To: Paul Libby, Highway Safety & Design Project Manager
 MLM
From: Marcy Meyers, Geotechnical Engineer, via Callie Ewald, P.E., Senior Geotechnical Engineer
 CEE
Date: July 23rd, 2014
Subject: Mt. Holly STP 0133(8) – Slope Recommendations Addendum

Figure 1: Proposed Vegetated Slope at Sta. 609+55 with Failure below Bench

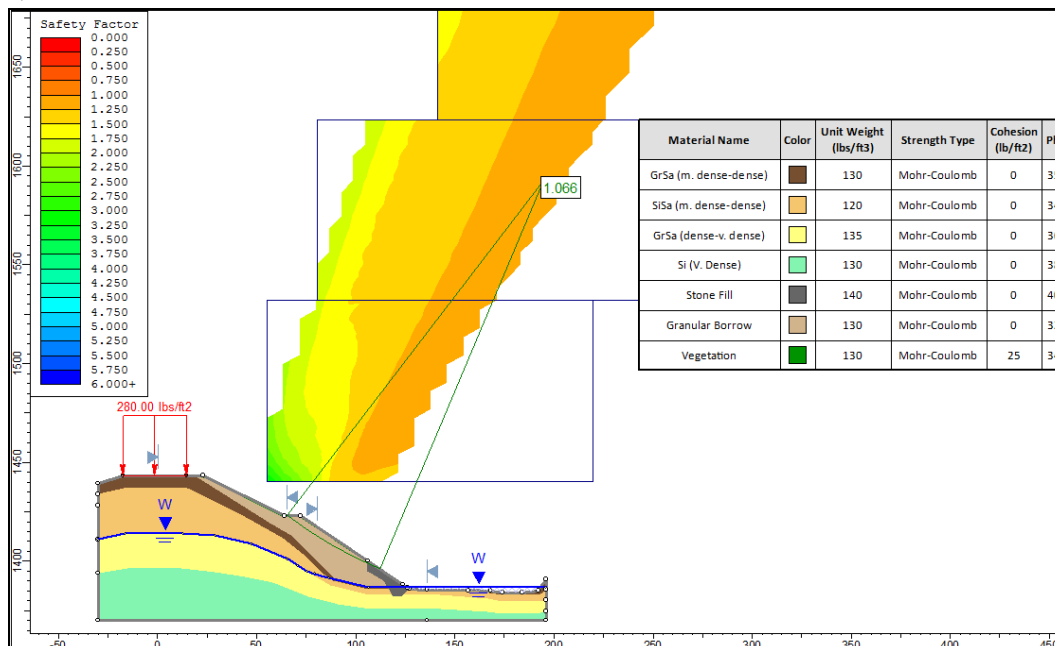
After review of the proposed vegetated slope for Sta. 609+55 (the critical section as determined in the first geotechnical report), the 1V:1.5H vegetated slope below the bench and above the stone fill raised concern of the potential for surficial slope failure. A computer model was generated using the software program, Slide, version 6.0, developed by Rocscience for Sta. 609+55 using the Bishop Simplified Method, and our initial concerns were confirmed. Results from this model indicated a failure surface occurring in the 1V:1.5H slope below the bench and above the stone fill as seen in Figure 1.

In order to address the instability while still maintaining the vegetated slope alternative, removing the bench and regrading the slope to a 1V:2H was evaluated. The stone fill remained in place at the same offset as specified in the sections provided by Green. A 1 foot thick layer of vegetation was input in Slide to model the surficial stability that the actual in place vegetation will provide for the surficial soils on the slope. A Slide model using the Bishop Simplified Method was evaluated and results can be found in Figure 2.

Figure 2: Revised Vegetated Slope at Sta. 609+55 with Failure in Stone

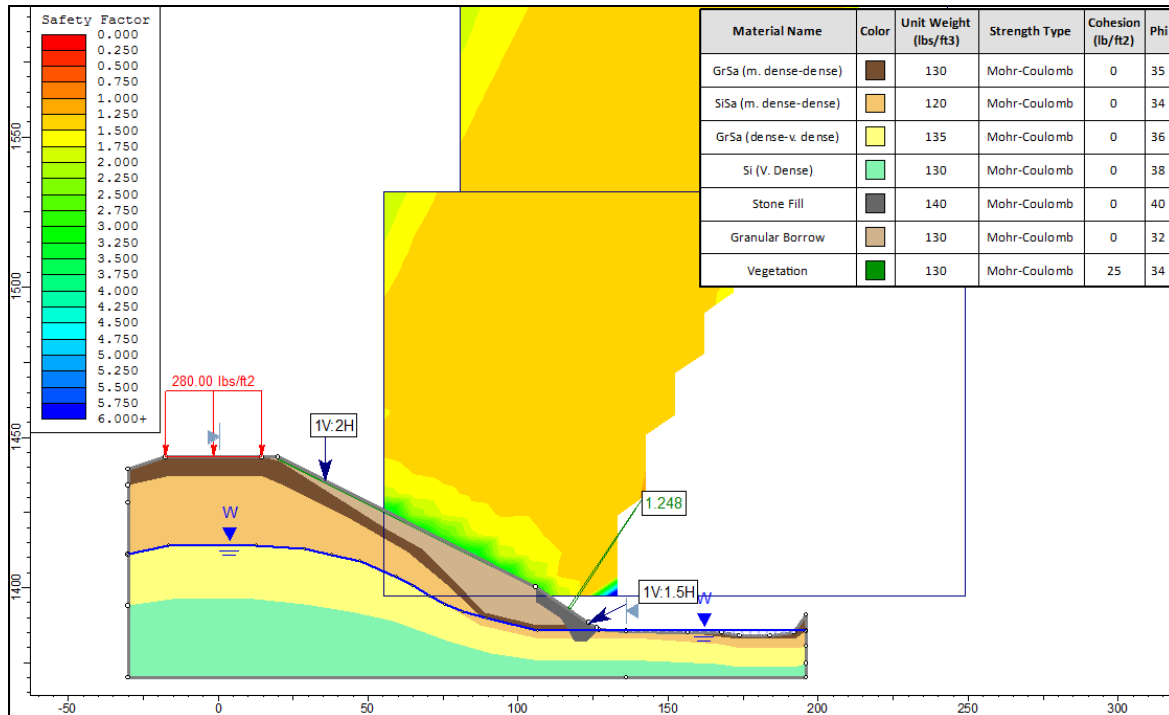
Although this minimum factor of safety of 1.25 is below AASHTO’s recommended value of 1.3, we are comfortable with this value as the failure surface is occurring in the stable Type IV stone fill section.

We recommend using a revised grade for the slope being vegetated as seen in Figure 2 (and also attached) for the unstable slope present at this site. The toe armoring of Type IV stone fill should be kept the same as detailed in the sections provided by Green, however we recommend beginning the 1V:2H grade from the top of stone and continuing it to the shoulder of the roadway. This does narrow the bench at the top of the slope, but still leaves approximately 5.5 feet of a bench from the guard rail to the top of slope. As mentioned in Section 2.0 above, a 1 foot thick layer of vegetation was used in the Slide models. It is our understanding that the vegetation for the slope will be designed by others and that surficial stability will be taken into account when developing details for the proposed 1V:2H vegetated slope.
